CITY PLANNING COMMISSION

- APPLICATION:
- A. Special Permit to allow a 5,610 square foot addition to an existing church
 - B. Variance to waive the required six foot high solid masonry wall

LOCATION: 7185 Elder Creek Road

PROPOSAL: The applicant is requesting the necessary entitlements to expand the existing church by adding a 5,610 square foot sanctuary area.

EAST ELEVATION

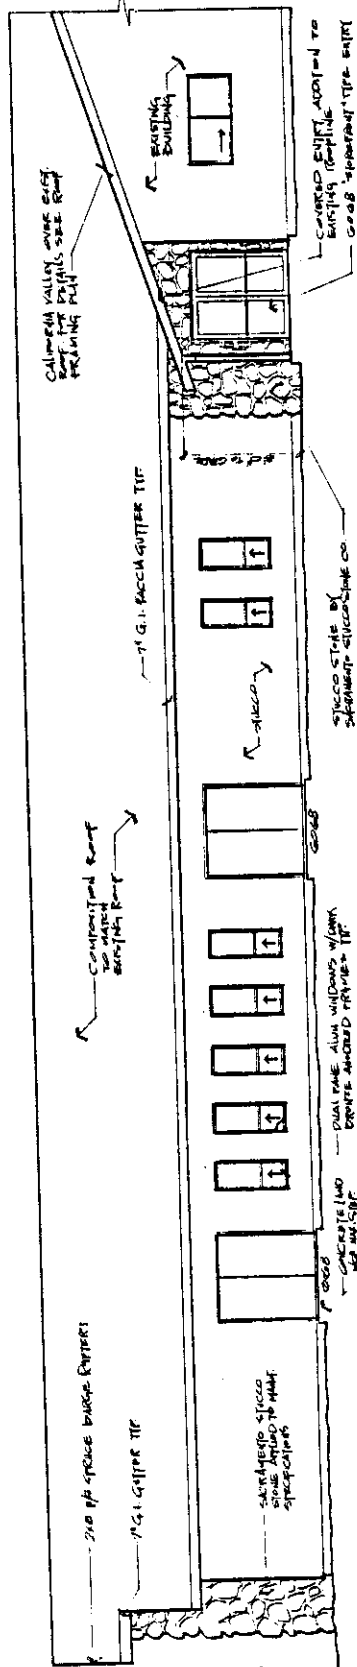
Staff has reviewed the elevations submitted and has the following comments. The proposed elevations present a spartan exterior with the only decorative relief provided by stucco stone on a portion of the south and east elevations. Further architectural embellishment needs to be added to the proposed building to provide a more visually interesting structure. Staff recommends the following changes be incorporated into the proposed building addition:

1. provide additional exterior building materials to increase the variation and type of building materials;
2. the proposed windows located along the east and west building elevations need to relate to each other as an architectural unit. This could be accomplished through the addition of vertical or horizontal wood trim or a change in the surface plane;

3. add vertical wall trellises for planters to support vines for bland wall areas. Staff recommends these trellises also be added to the existing blank building walls;

4. Evergreen shrubs and five gallon Evergreen trees shall be planted directly in front of the proposed south, east and west building walls to provide some landscape buffer to the proposed church addition;

5. the roof material should be thick butt composition shingles with a minimum 25 year life span.
6. revised building elevations shall be submitted for the review and approval of the Planning Director.

1. Revised elevations shall be submitted for the review and approval of the Planning Director and shall incorporate the following:
 - a. additional exterior building materials shall be provided;

- b. additional vertical or horizontal wood trim or a change in surface plane shall be added to the window areas;
 - c. vertical wall trellises for planters supporting vines shall be added to the blank wall areas on the existing church and proposed church addition;

- d. Evergreen shrubs and five gallon Evergreen trees shall be planted directly in front of the proposed south, east and west building wall to provide some landscape buffer to the proposed church addition;

- e. the roof material should be thick butt composition shingles with a 25 year life span.
2. The parking lot driveway shall be a minimum of 30 feet wide as required by the City Traffic Engineer.

EXHIBIT A

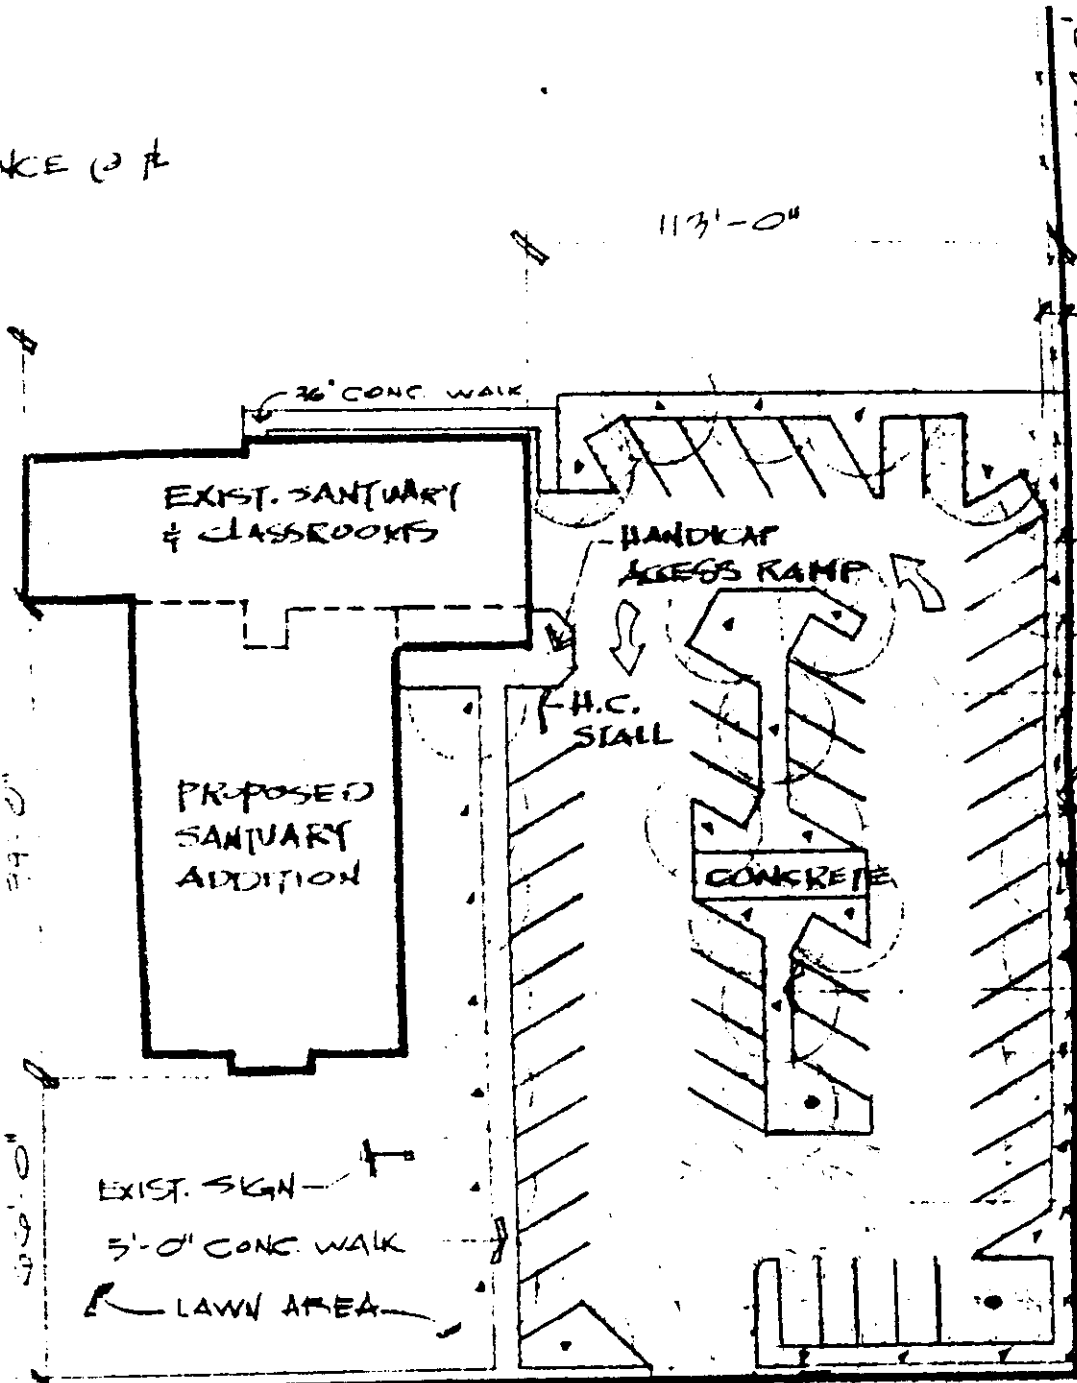
Traffic Engineering has reviewed the parking lot design and has the following comments: The proposed minimum driveway width shall be 30 feet and not 20 feet as proposed. The

planter aisle located nearest to the front property line shall be relocated to the north the required 44 feet to provide an increase in the turning radius for cars entering the parking lot. This will require a loss of one parking space and a relocation of four other parking stalls. (See exhibit A).

1. Two way driveway to be a minimum of 30 feet wide
2. Move cross isle further from street. See Exhibit A.

3. The parking cross isle shall be moved back from the street and the affected parking stalls revised accordingly as per exhibit A.
4. The weeds in the area between the existing church and the north property line shall be regularly mowed at least twice a year.
